Your Ref: NYM/2018/0730/FL

DEVELOPMENT AT SYCAMORE COTTAGE WEST END AMPLEFORTH

Job Title
Outbuilding to the rear of Sycamore Cottage Ampleforth
for Mr Paul Judge

Drawing Title
Revised details

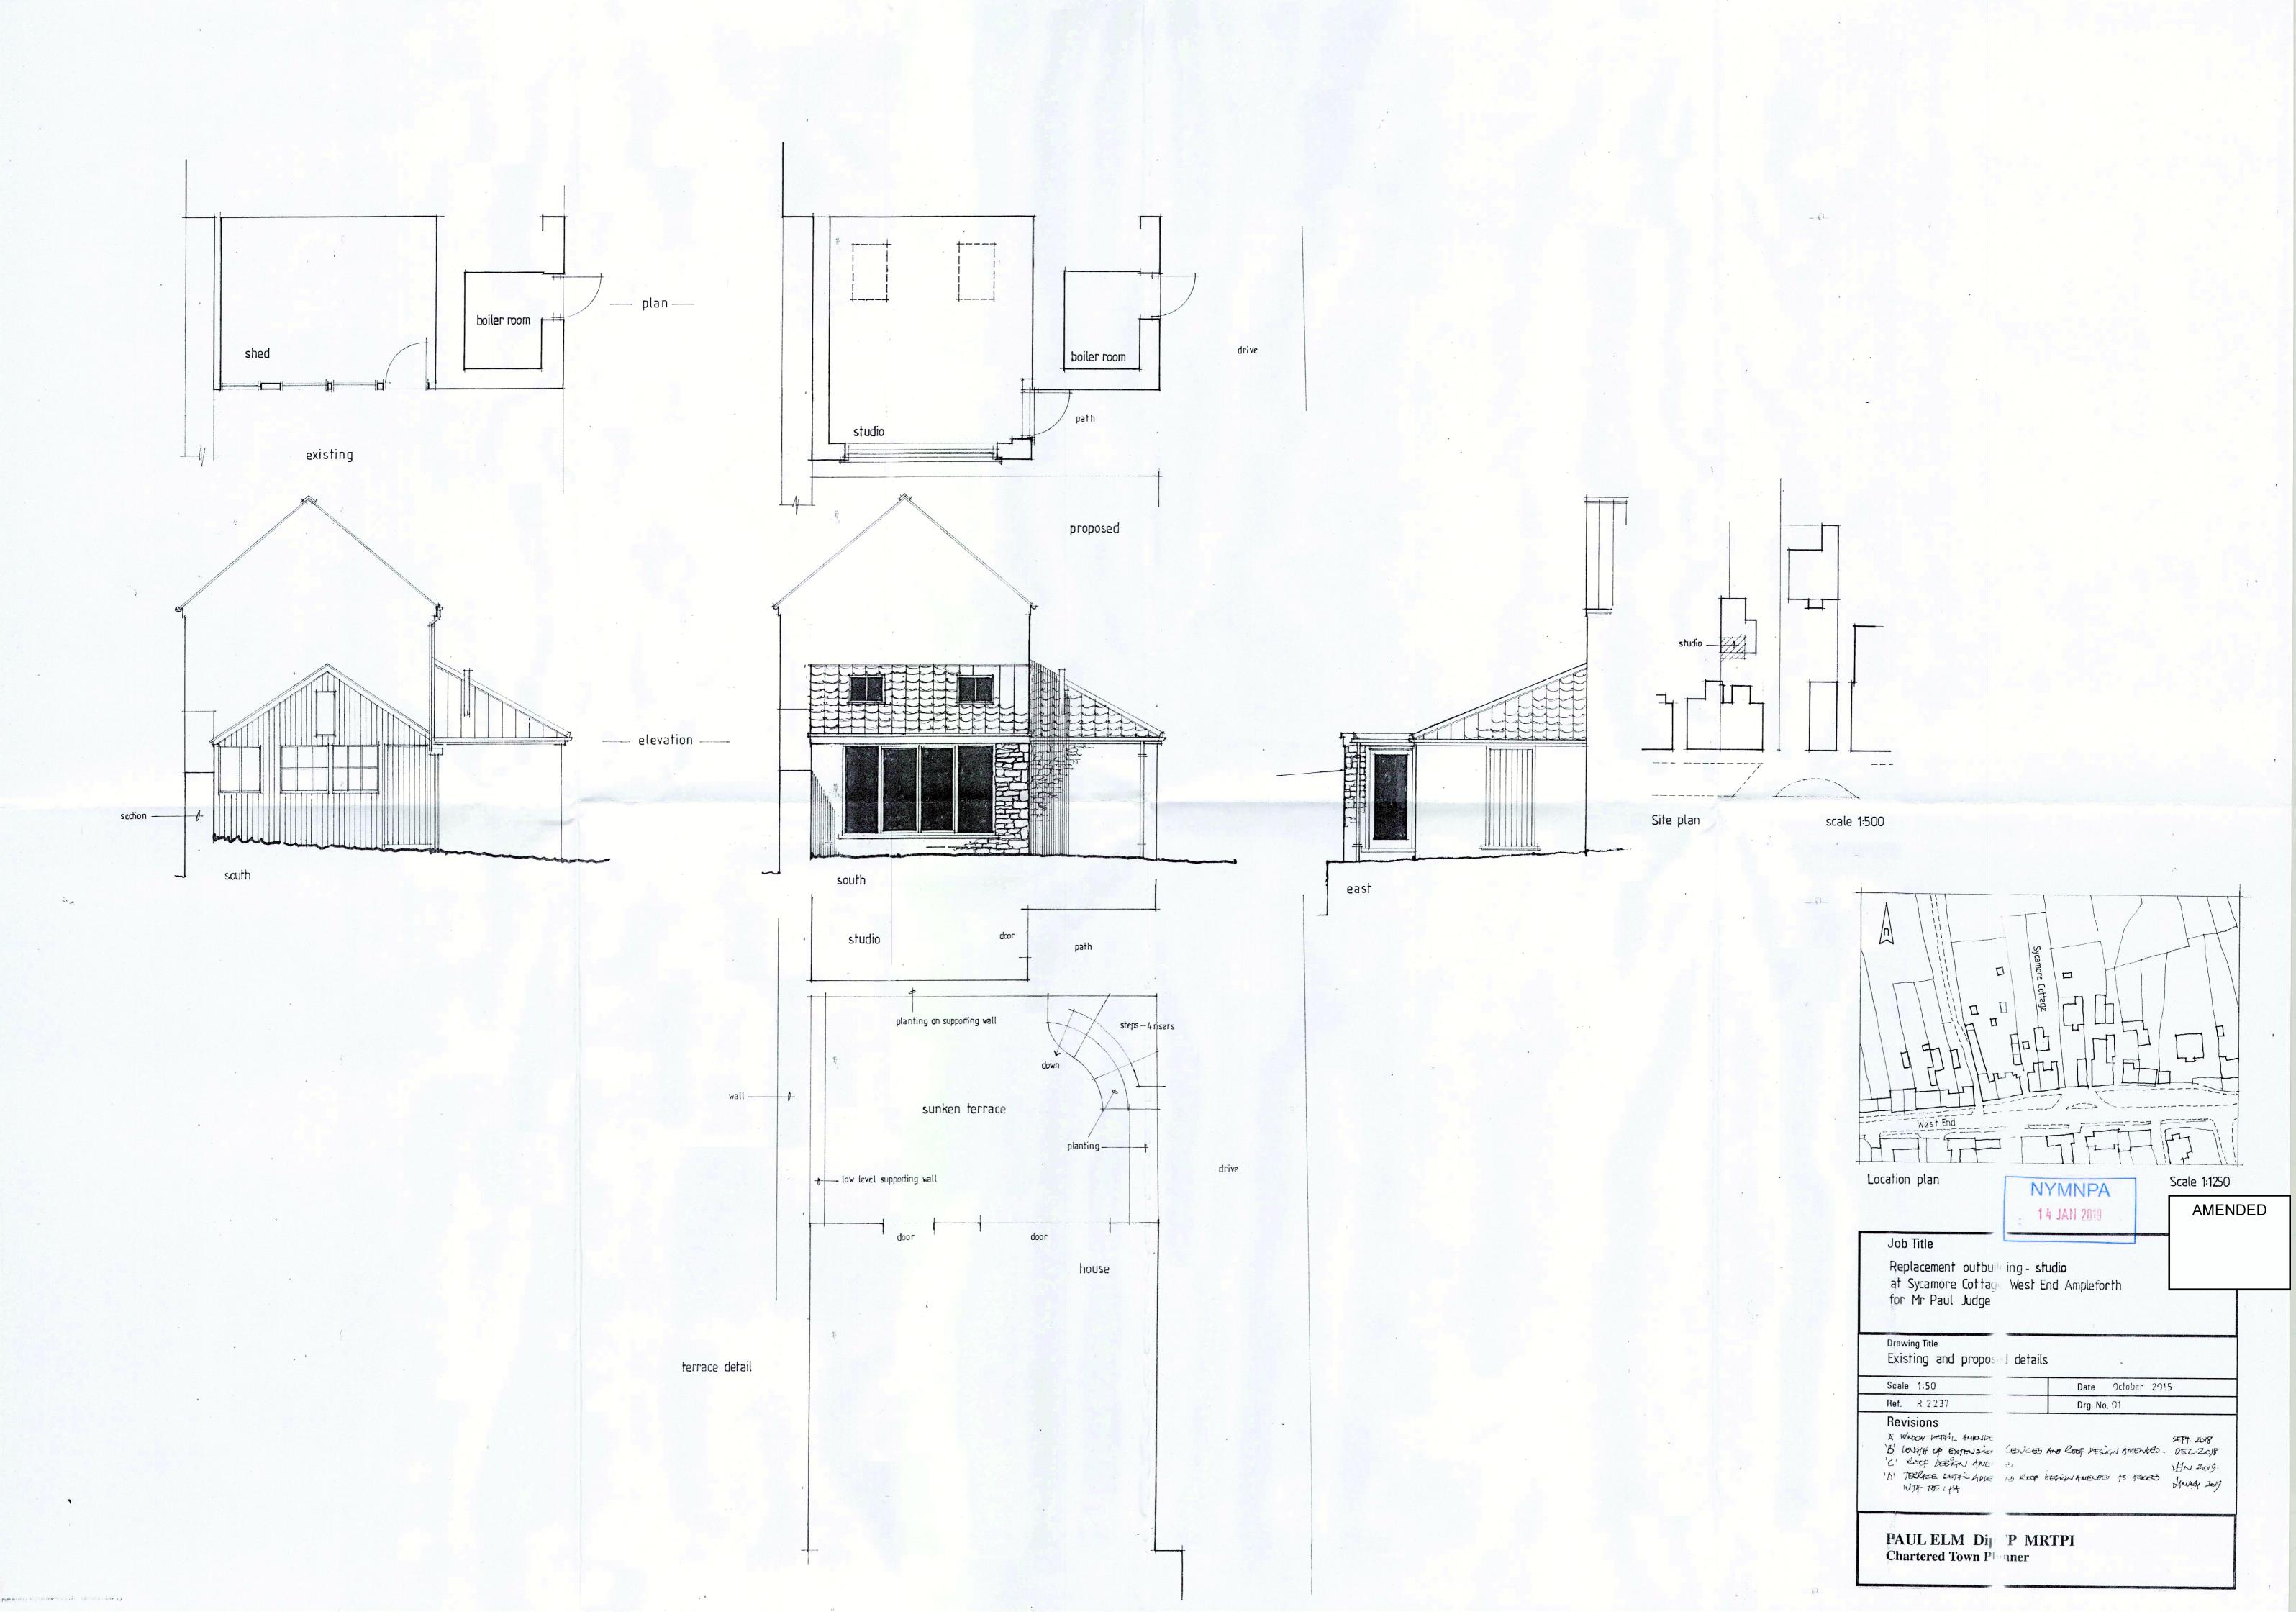
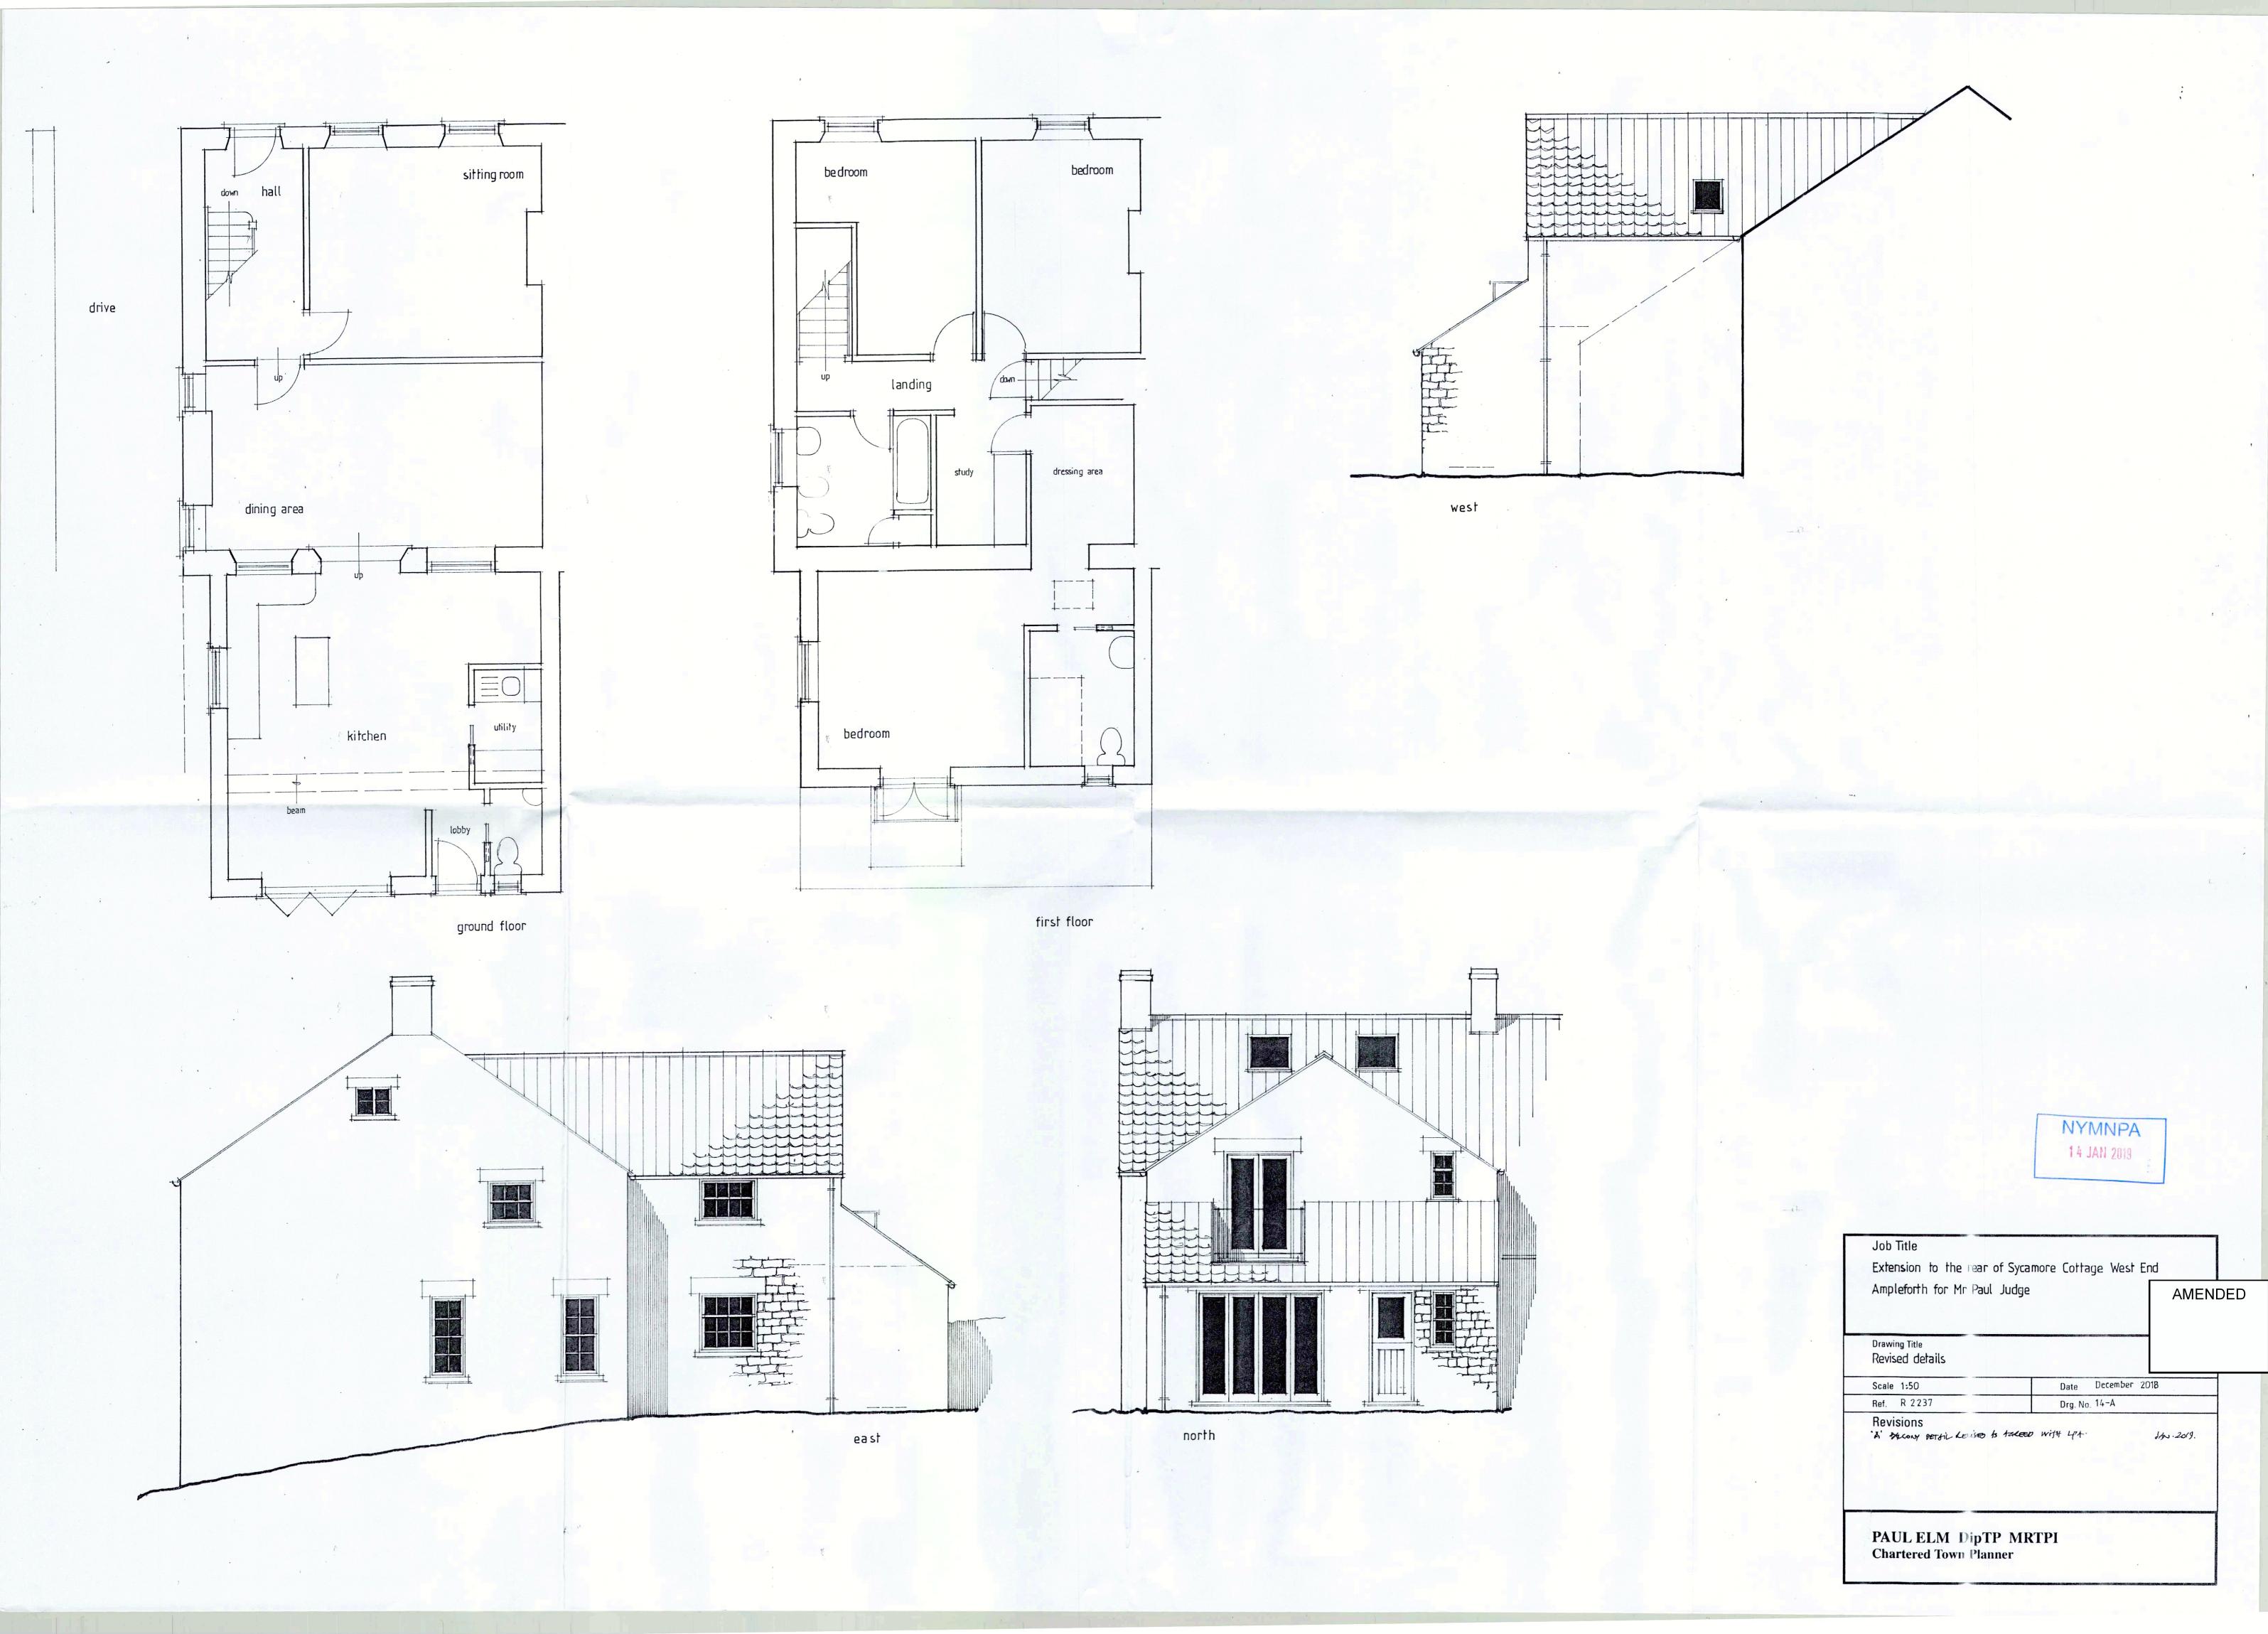
With regard to the extension to the house, I had already reduced the length of the upper storey as you had suggested in your letter. However, you expressed concern about the inclusion of a balcony on the rear elevation of the proposed bedroom. In line with the agreed compromise, I have now reduced the balcony area so that it is just large enough to accommodate the outward opening doors. This was the only revision that you requested to this part of the proposal.

Moving on to the alteration of the outbuilding at the rear of the house, I have altered the roof height and design as was agreed. The slope now aligns with the one above the boiler room. To accommodate the extra length of the roof above the studio, I have shown a strip of flat leaded roof which will drain to a gutter above the studio door. There will be two 'conservation' roof lights in the south facing roof slope. On this drawing I have also given an indication of the layout of the proposed sunken terrace to be created between the rear of the house and the outbuilding. This will be approximately 1m below the existing ground level, so should rule out any overlooking of adjacent properties. My client would like to create a curved line of steps from the level of the drive down into the terraced area to give access to the doors in the rear elevation of the extension. There will be planting on the 'shelving' alongside the steps and in front of the studio window. I enclose a copy of my client's computer generated drawing which gives an idea of how the terrace might look.

Scale 1:50
Date January 2019
Ref. R 2237
Drg. No. 20-A

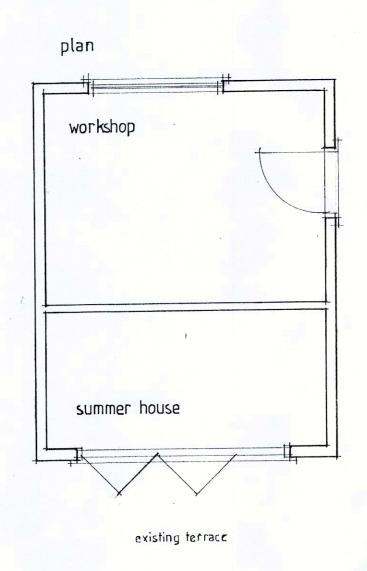
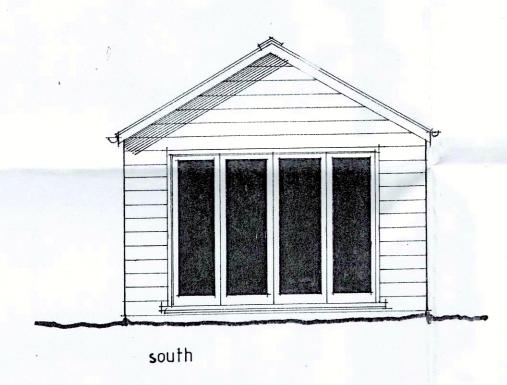
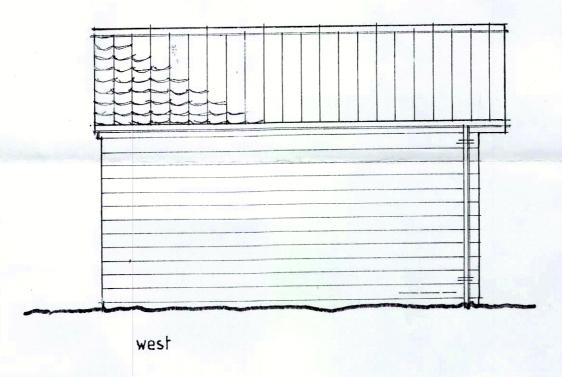
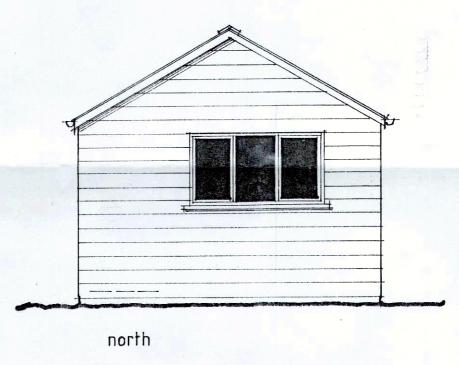
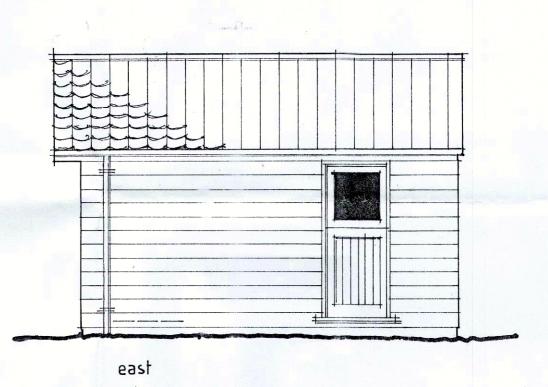
The third part of the scheme is the creation of a summer house/workshop on the existing stone flagged terrace further up the garden. In line with your suggestion, I have reduced the size of this building and re-aligned it so that the ridge runs north-south rather than east- west. Since our meeting Mr Judge has reconsidered the roofing of this building, he would now prefer to use terracotta roof tile panels as manufactured by Jacksons of Stockton on the Forest. I enclose a copy of part of their brochure for your information.

Walls: Tanalised horizontal timber boarding

Roof: Jackson's roof tile panels – terracotta

Rain water goods: Black uPVC
